Origination Form

Proposed Revisions to a Standard Plans Index

Originator:	Turley, Joshua	Index Number:	521-660
Date:	5/14/2024	Sheet Number(s):	2, 4
E-mail:	Joshua.Turley@dot.state.fl.us	Index Title:	LIGHT POLE PEDESTAL - BRIDGE

OPTION 2 - TYPICAL SECTION AT LIGHT POLE PEDESTAL (Approach Slab Similar)

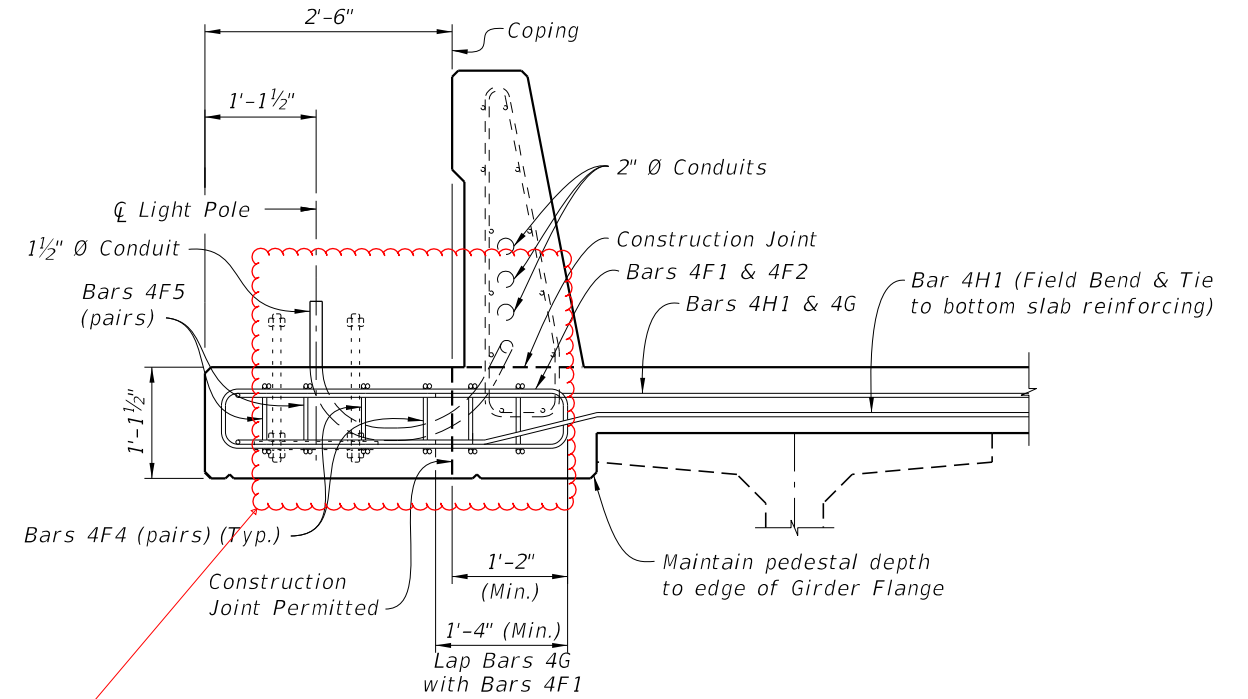
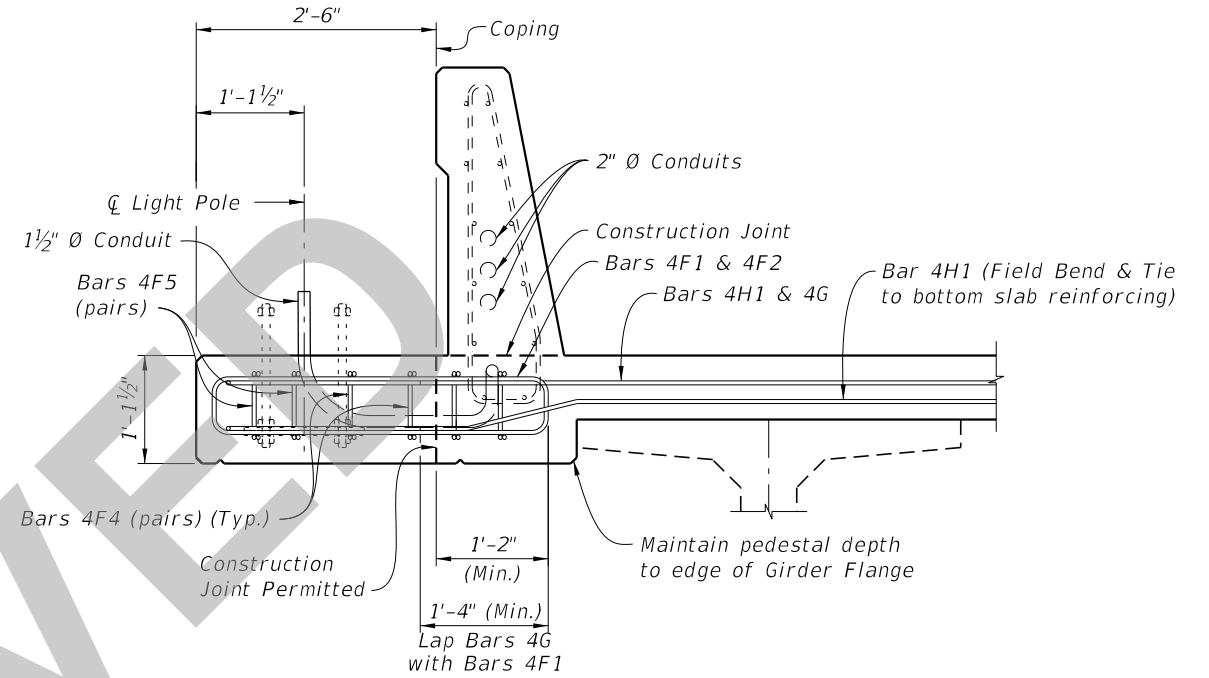
Sheet 2: Revised conduit path for the TYPICAL SECTION's.
 Sheet 4: Labeled the anchor bolt nuts in DETAIL "A"; Added a note for DETAIL "A" regarding minimum anchor bolt embedment and bottom concrete cover; Removed anchor bolt table; Revised Note 4 to now include maximum deck height, pole height, and pole arm length

Sheet 1: Conduit path was slightly incorrect so we fixed it.
 Sheet 4: The anchor bolt nuts were labled to correspond with the Spec. The anchor bolt table was removed so that this Index will only address the standardized pole and pedestal capacities. The pole mounting height is limited to 40 feet for an elevated structure mount.

Match the conduit curvature path of sheet 1 option 1.
